Addendum No. 2
To the Plans, Specifications, Proposal and Contract

City of Kirkland
Fire Station 26 Renovation
9930 124th Ave NE, Kirkland, WA 98033
CIP # PSC 3006 000
JOB # 46-23-PW

ISSUED THIS DATE:	December 7th, 2023
BID SUBMITTAL TIME/DATE/LOCATION:	Prior to 1:00 P.M. on December 12, 2023 at Cashier - City of Kirkland 123 5th Avenue Kirkland WA 98033

3RD & 4TH FLOOR LIGHTING FLOOR PLAN
SCALE: 1/8" = 1'0"

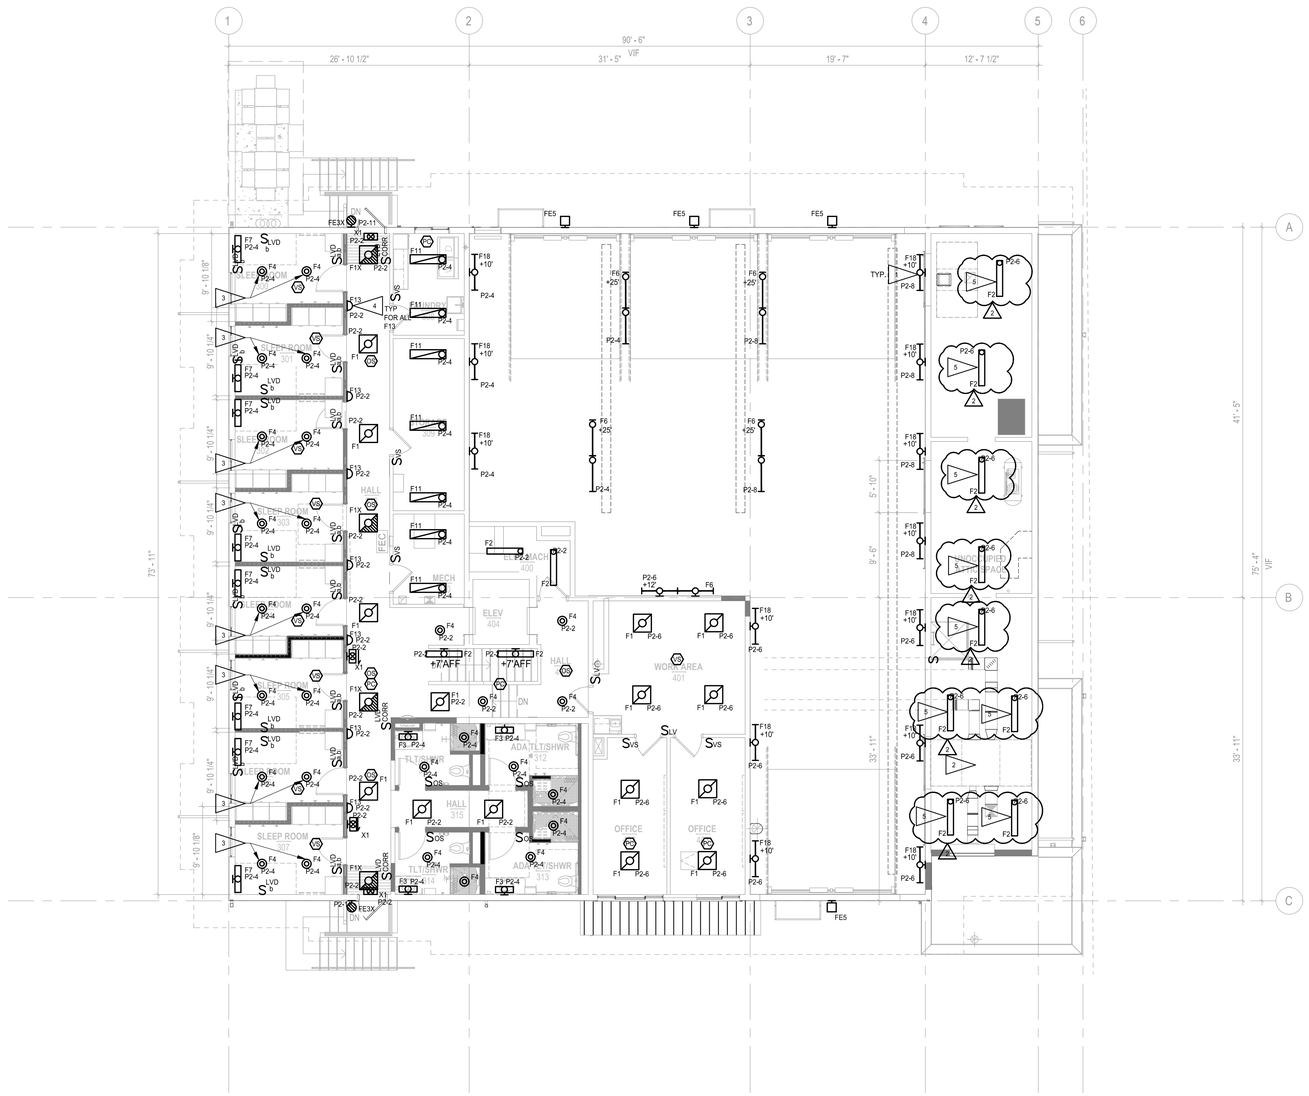
2. Replace sheet issued for bid with attached sheet dated December 7, 2023. Changes include:
   a. Add Flag Note 5 per attached revised sheet E3.2.
   b. Add Flag Note 5 to fixtures in attic space per attached revised sheet E3.2.

1 E3.1 1ST & 2ND FLOOR MECHANICAL POWER FLOOR PLAN

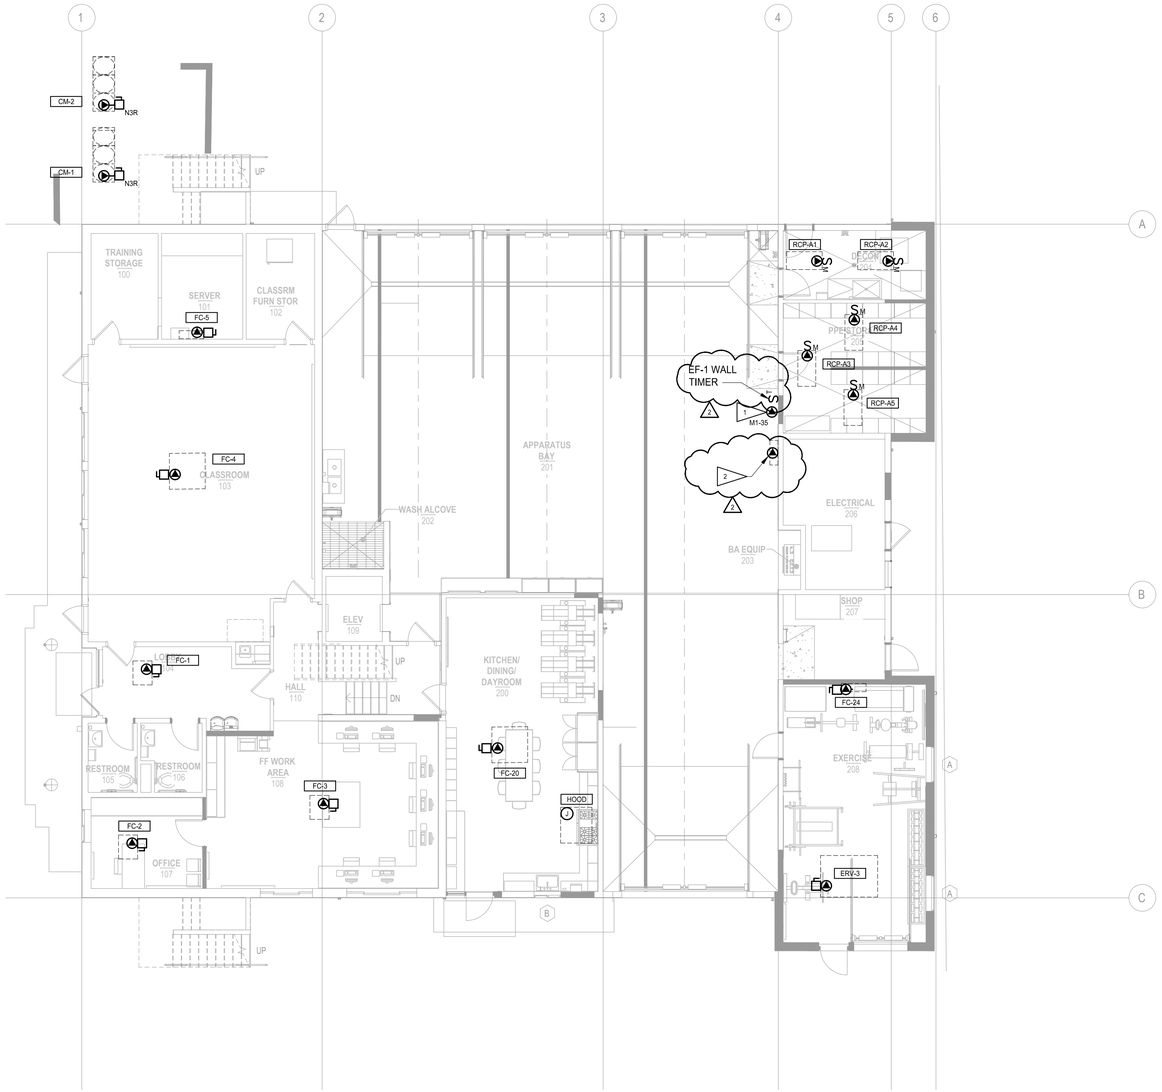
1. Replace sheet issued for bid with attached sheet dated December 7, 2023. Changes include:
   a. Add Flag Note 2 for Nederman Control Panel.
   b. Add Nederman Control Panel location to apparatus bay wall.
   c. Add EF-1 timer switch location to apparatus bay wall.

1 E4.3

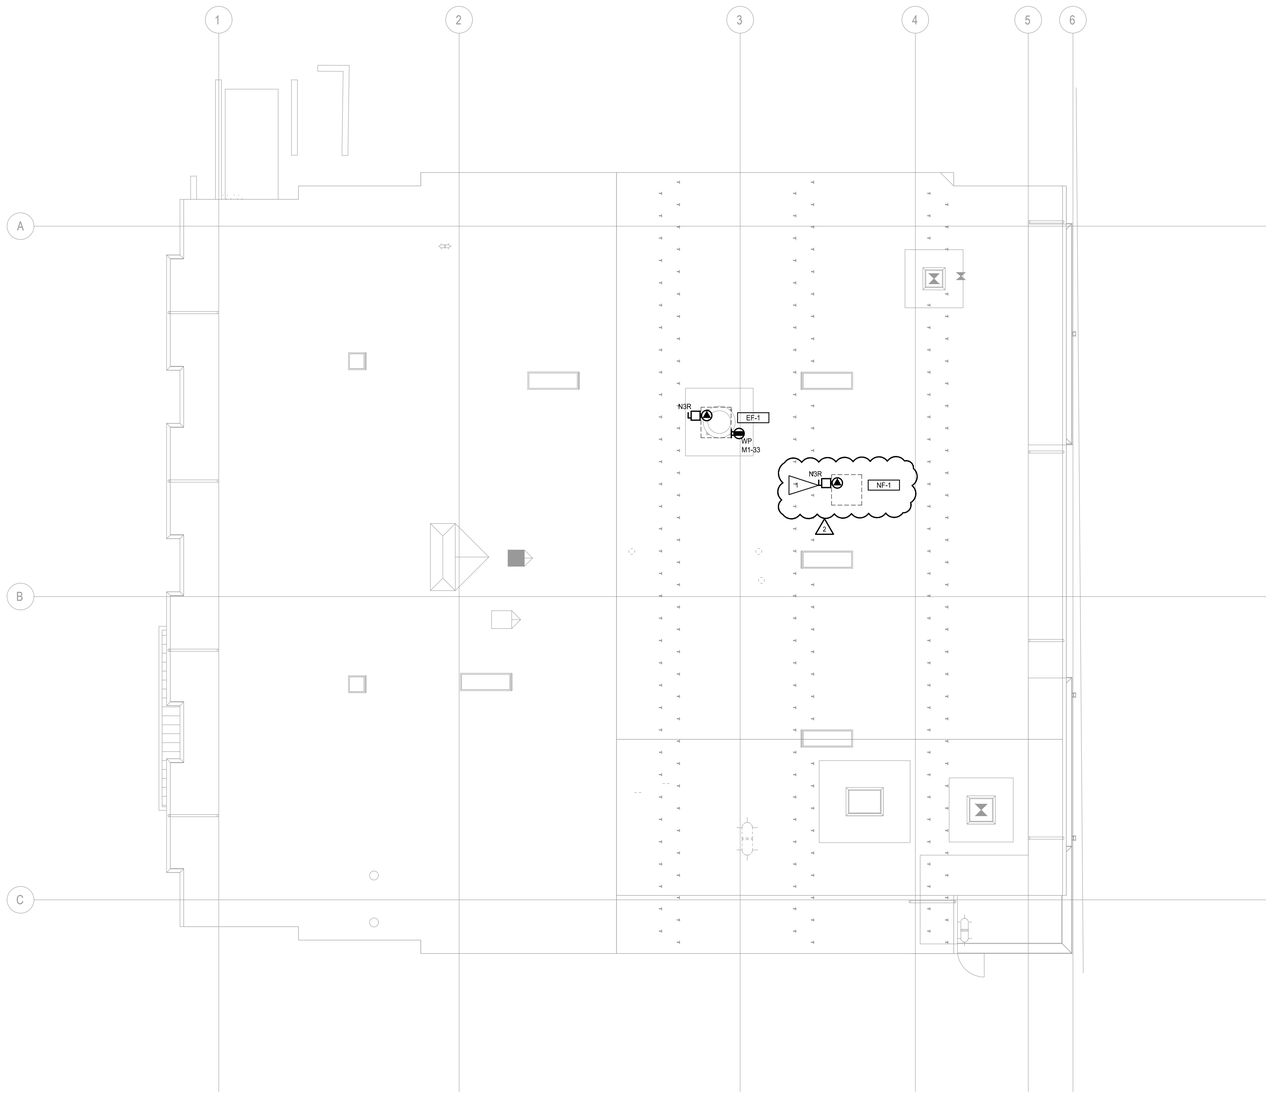
1. Replace sheet issued for bid with attached sheet dated December 7, 2023. Changes include:
   a. Add Flag Note 1.
   b. Add connection to bidder designed source capture exhaust system.

5 E8.2 DETAIL - NEDERMAN CONTROL PANEL DETAIL
SCALE: NONE

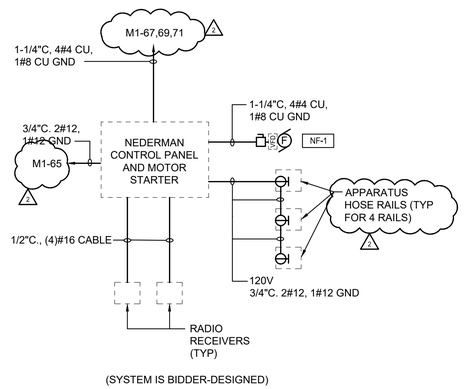
a. Revise circuiting shown on Detail 5, NEDERMAN CONTROL PANEL DETAIL.

1 E9.1 ONE LINE DIAGRAM
SCALE: NONE

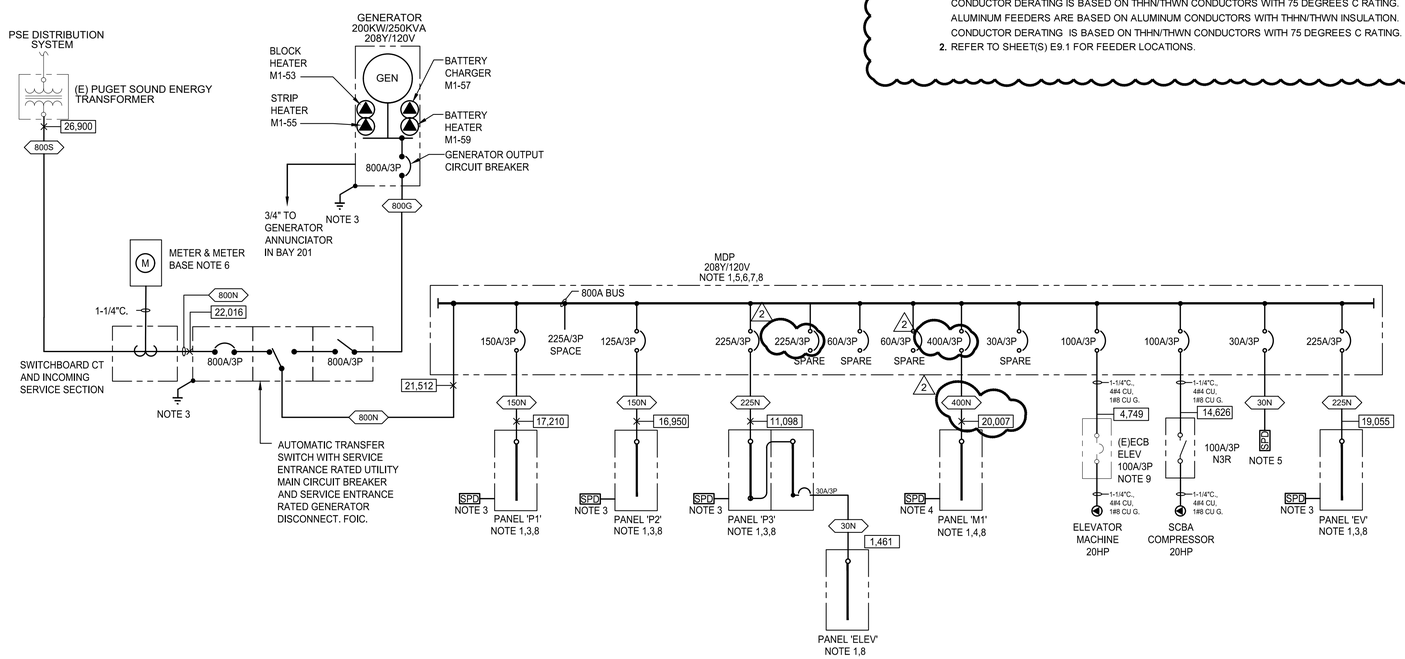
2. **Question:** *We are unable to find the Feeder Matrix on drawing E9.1.*
   Answer: Feeder Schedule added to Addendum 1. See Addendum 1 and revised schedule as part of Addendum 2.

1. Replace sheet issued for bid with attached sheet dated December 7, 2023. Changes include:
    a. Revise feeder schedule per attached revised sheet E9.1.
    b. Revise Panel M1 feeder to 400N.
    c. Revise 400A/3P Spare to serve Panel M1. Spare out 225A/3P breaker previously serving Panel M1.
    d. Revise available fault current tag at Panel M1 to reflect feeder reconfiguration.
